**COUNTY OF ALBEMARLE
STAFF REPORT SUMMARY**

Project Name: ZMA201500002 Franklin Street	Staff: J.T. Newberry, Bill Fritz
Planning Commission Public Hearing: May 19, 2015	Board of Supervisors Public Hearing: TBD
Owner: Realty IX, LLC	Applicant: Julia Skare, Draper Aden Associates; Mark Mascotte, McLean Faulconer, Inc.
Acreage: 11.77 acres	Rezone: 31,894 square feet of preserved slopes to managed slopes within Steep Slopes Overlay District (18.30.7)
TMP: 07700-00-00-040B0	By-right use: Light Industry uses
Magisterial District: Scottsville	Proffers: No
Proposal: Amend Steep Slopes Overlay District to change designation of an area of 25%> slopes from Preserved slopes to Managed slopes as identified on the application plan.	Requested # of Dwelling Units: Not applicable to this request.
DA (Development Area): Neighborhood 4	Comp. Plan Designation: Industrial Service – warehousing, light industry, heavy industry, research, office uses, regional scale research, limited production and marketing activities, supporting commercial, lodging and conference facilities, and residential (6.01-34 units/acre)

PROJECT: ZMA201500002 Franklin Street Steep Slopes

PROPOSAL: Request to change the zoning

Figure 1: Areas of Slopes

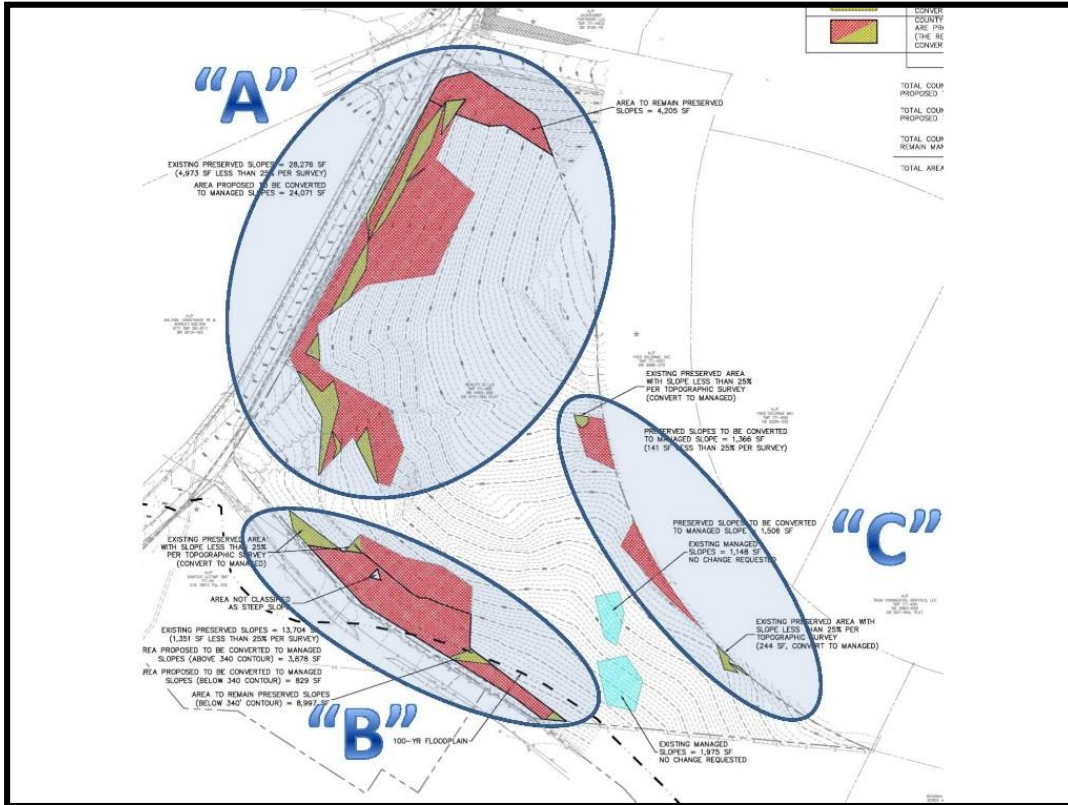
The characteristics of preserved slopes and managed slopes are outlined in Section 30.7.3(a) and (b) respectively and represent the specific criterion used to determine the appropriate designation of steep slopes (see Attachment D). Broadly, staff found the steep slopes on this parcel contained characteristics of both managed and preserved slopes, but will make reference to three distinct areas on the site labeled as “A”, “B” and “C” in the figure below to further explain our analysis.

Figure 3: Context of slopes connecting to area "A"

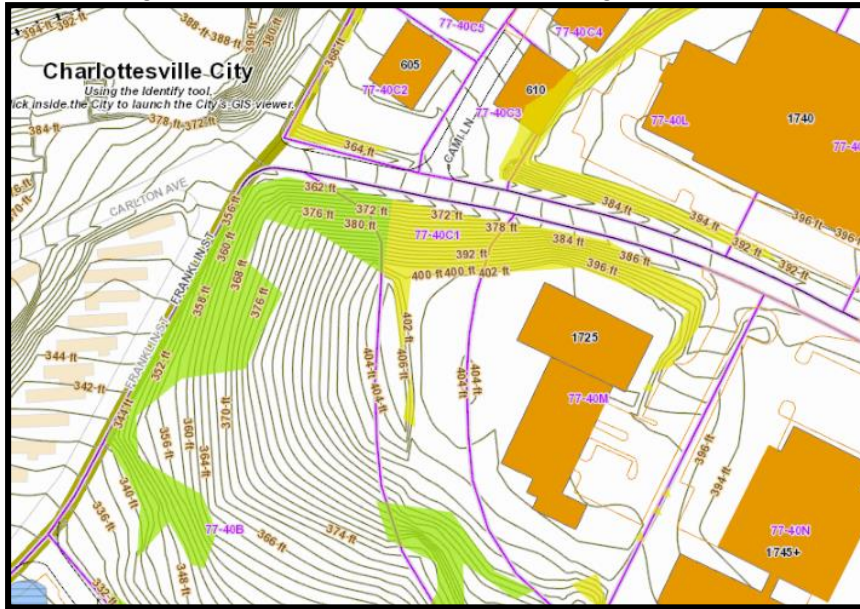
Staff also found the context of slopes for area "A" to be an important factor to consider. The adjacent properties to the west of the subject parcel (Parcel 40C1 and Parcel 40M) show a large area of managed slopes across the front of their property (shown in yellow in Figure 3). These slopes connect seamlessly to the preserved slopes at the northern end of the subject parcel (shown in green), which might suggest a "hillside system" that would be characteristic of preserved slopes. However, historical maps and engineering review suggest that all of the steep slopes along the southern side of Broadway Street were the result of road construction. Therefore, although the preserved slopes on the subject parcel are a part of a hillside system, that system is mostly manufactured and was significantly disturbed prior to June 1, 2012. This feature is more characteristic of managed slopes.

Furthermore, there is some additional disturbance that’s already been approved in this area and some additional disturbance that is anticipated. In 2013, Yves Delorme received a critical slopes waiver to construct a road to provide access from Parcel 40M to Parcel C1, which would further fragment this slope system.

Staff ultimately recommends that all 28,276 square feet of the preserved slopes in area “A” should be rezoned to managed slopes.

Figure 4: Area “B”

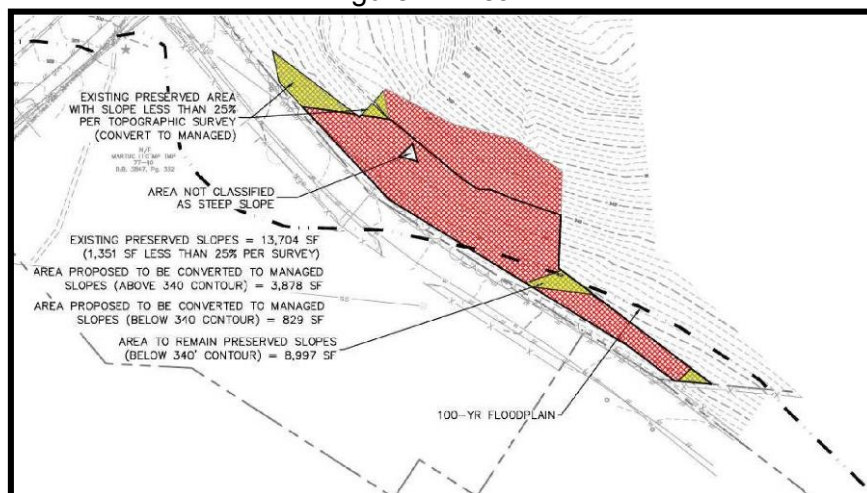
This area contains the second largest area of steep slopes on the site at 13,704 square feet. The total square footage requested to be rezoned in this area is reduced by the 8,997 square feet proposed to remain as preserved slopes adjacent to the southern property line and by the 1,351 square feet shown to be less than 25% grade by field run topography (outlined in yellow in Figure 4). Subtracting these areas yields a total of 3,356 square feet of preserved slopes to be rezoned to managed slopes in area “B.”

Staff found more characteristics of preserved slopes than managed slopes within this area. The areas determined to be less than 25% grade were mostly found on the periphery of this system and it still yields a contiguous area of more than 10,000 square feet when those areas are subtracted. It is located partially within the floodplain of Moores Creek, so it is associated with an abutting water feature. It is also connected to a much larger system of slopes (see Figure 5 below). Staff believes that even if some portion the steep slopes are the result of the construction of Moores Creek Lane, the size of its contiguous area and proximity to the most impaired watershed in the County warrants its preservation.

Figure 6: Area “C”

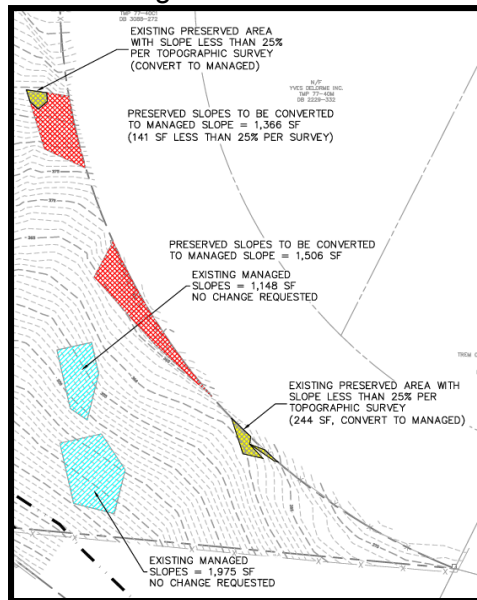
This area contains the smallest grouping of steep slopes on the site at approximately 3,116 square feet. The total square footage requested to be rezoned in this area is reduced by the 385 square feet shown to be less than 25% grade by field run topography (outlined in yellow in Figure 6). Subtracting these areas yields a total of just 2,731 square feet of steep slopes to be rezoned from preserved slopes to managed slopes in area “C.”

The location of the property line makes these slopes look relatively small and unimportant, but they're actually a part of a much larger system on the County's maps (see Figure 7). Although the field run topography did show some portions of these areas as less than 25% grade, it's difficult to know if that is a more comprehensive characteristic within this system (as observed in area "A") or if it's indicative of only minor modifications along the edges of the system (as observed in area "B"). Without additional information, staff finds it appropriate to maintain these slopes as preserved slopes.

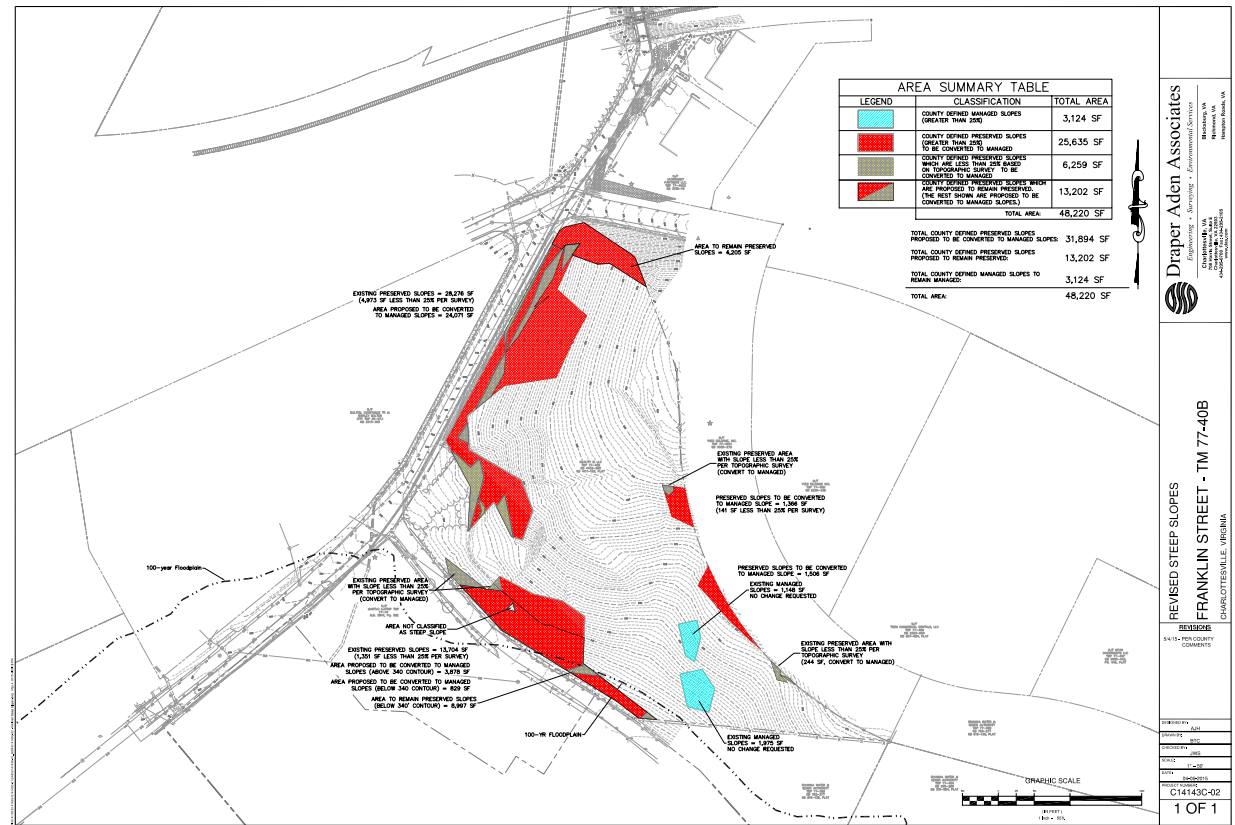
Above, photo taken from the intersection of Broadway and Franklin Street. The hillside pictured contains 28,000+ square feet of existing preserved slope. Below, a portion of the Moore's Creek Environmental Preservation Area which abuts parcel # 07700-00-00-040B0 to the south.

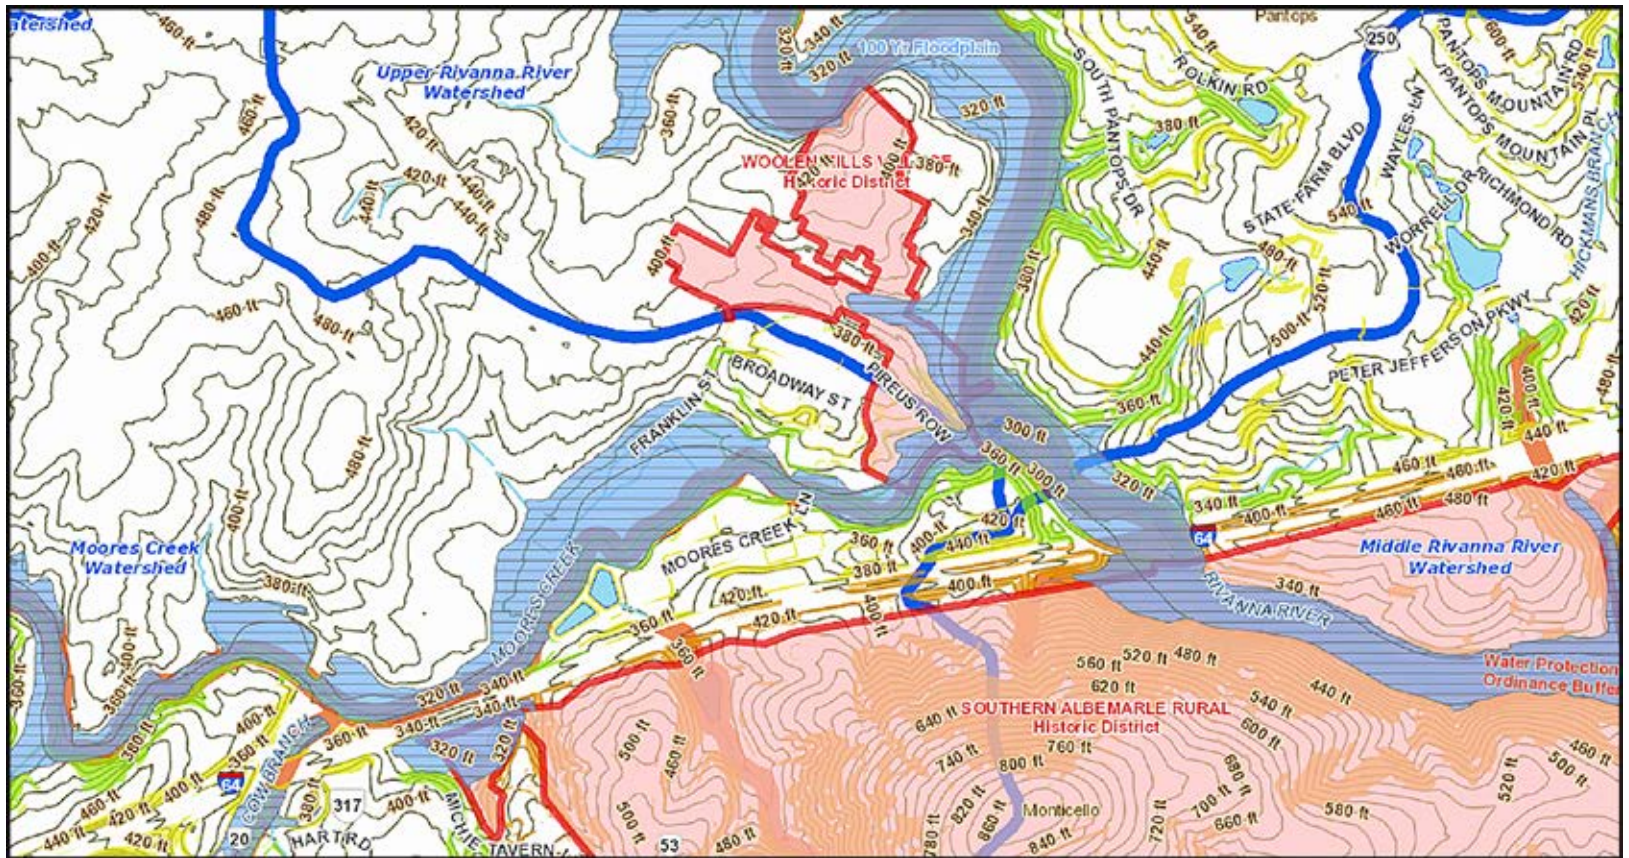
Yes, there are two areas in excess of ten thousand square feet, of contiguous preserved slopes. Visual documentation may be seen in the form of the Draper Arden Revised Steep Slopes Figure 1 above and the Steep Slopes Overlay District Map, Neighborhood 4 to the right.
